Mazda 3, 5 - Loss of coolant | HELLA

Loss of coolant

15-169

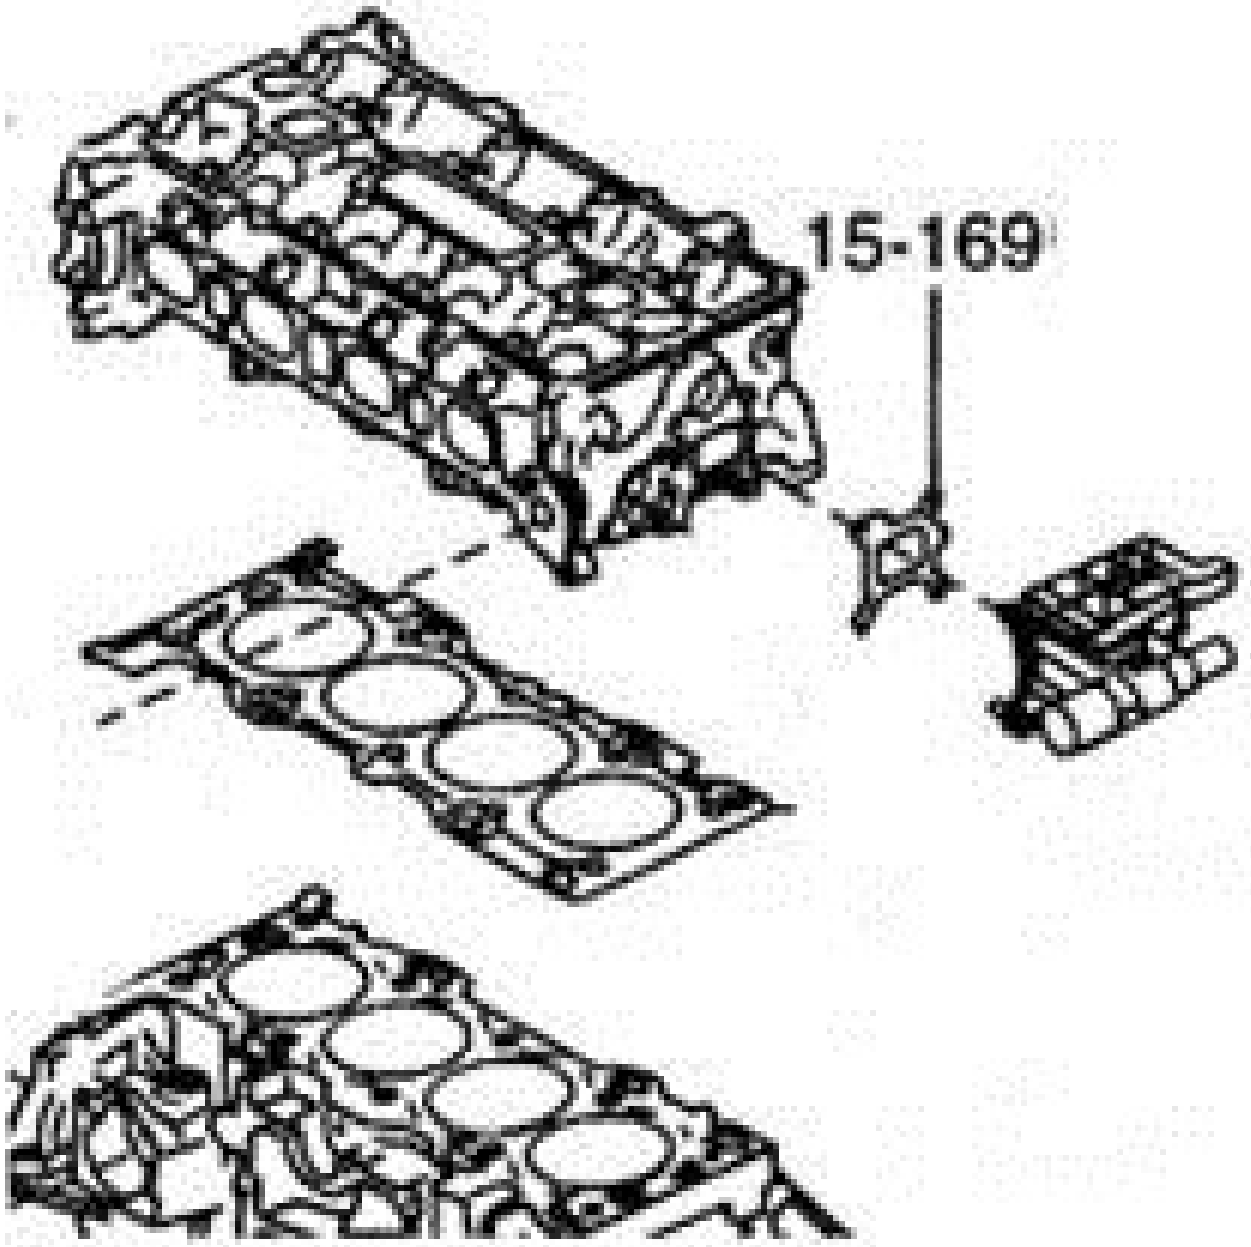
On the above vehicles (except for the Mazdaspeed 3), there is the possibility for coolant to leak out at the cylinder head flange.

In case of coolant loss, special attention should be paid to the coolant flange gasket on the cylinder head (drawing 15-169). It may need to be replaced with a modified variant (LF1F-15-169).

After the repair, refill and bleed the cooling system as per the manufacturer's specifications.
